APPLICATION FOR PLANNING PERMISSION 21/00446/DPP FOR RESIDENTIAL DEVELOPMENT INCLUDING FORMATION OF ROADS, PARKING, DRAINAGE, OPEN SPACE AND ASSOCIATED WORKS (AMENDMENT TO DESIGN, LAYOUT, HOUSETYPES AND NUMBERS APPROVED BY PLANNING PERMISSION 12/00745/DPP) AT LAND BETWEEN BELWOOD ROAD AND MAURICEWOOD ROAD, PENICUIK

Report by Chief Officer Place

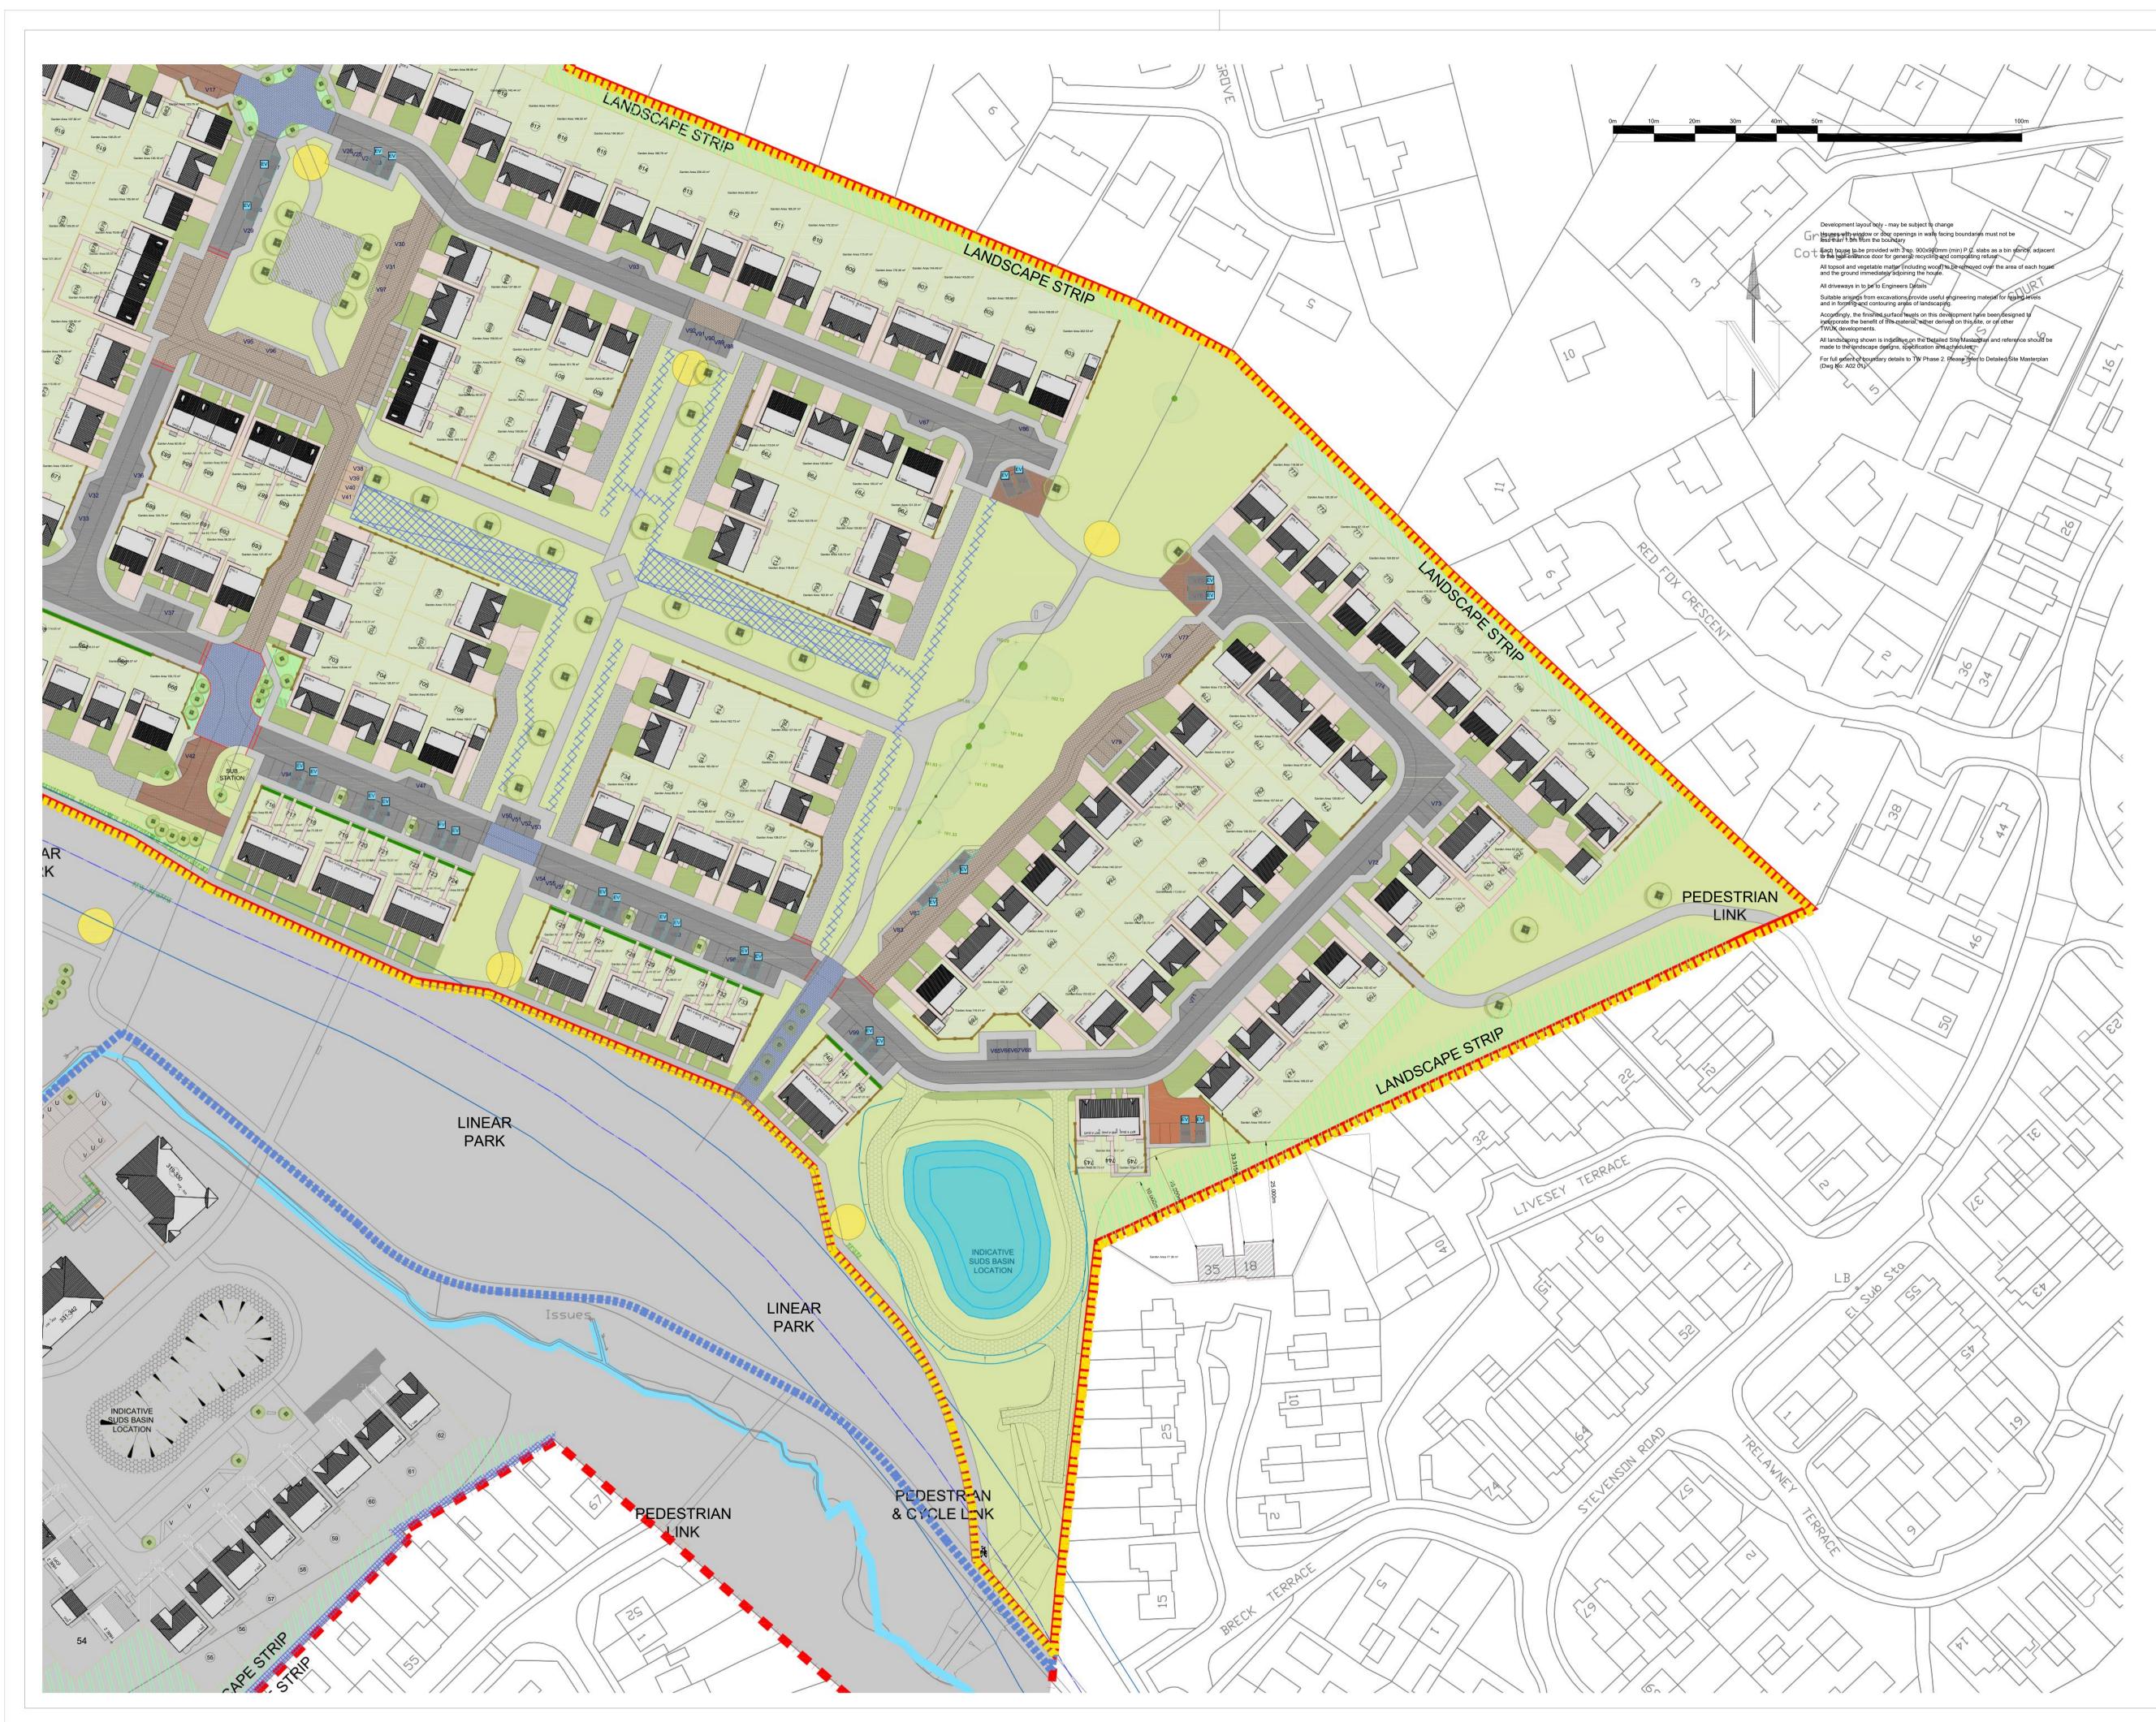
- 8.14 Concern further exists in relation to plot 601 and its relationship with the existing property at 61 Belwood Road (a bungalow). At this point a retaining wall and fence combination would create a 4.1m boundary feature. Despite proposals to screen the retention with landscaping, it is considered an inappropriate relationship with the existing property. These matters would conflict with the MLDP policy DEV5. For that reason plot 601 is not approved as part of this application and this is proposed to be secured through a planning condition.

15. Plot 601 is hereby not approved and no hard surfacing, foundations, or other works specific to that plot shall be carried out within the red line as added to plan ref: A02-40 rev L. Prior to the commencement of development on the site revised layout drawings shall be submitted showing the removal of plot 601 and the landscape scheme to replace it.
